Mountain View Elementary School

Town of East Longmeadow ADA Transition Plan

October 2025

Institute for Human Centered Design

Figure 1: In the following image, the yellow lines show approximate routes to connect the softball and soccer fields, along with the team seating areas associated with each field, to the nearest accessible routes from each parking lot.

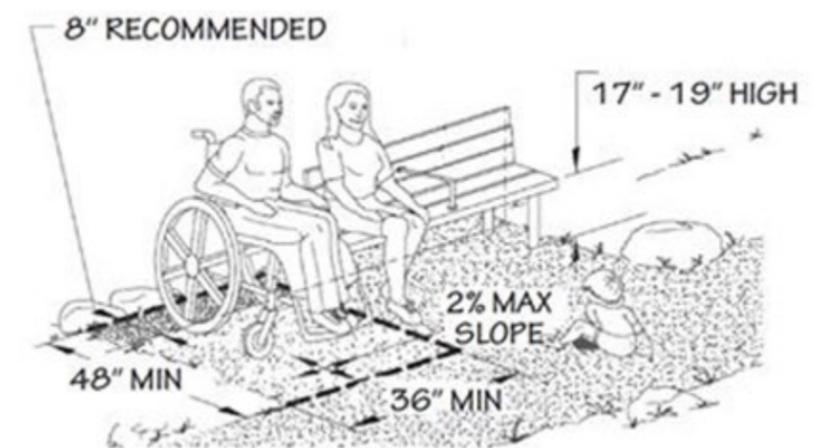
Accessibility issues include a lack of an accessible route to the softball and soccer fields, a lack of an accessible route to team seating area, and lack of accessible spaces at team seating areas.
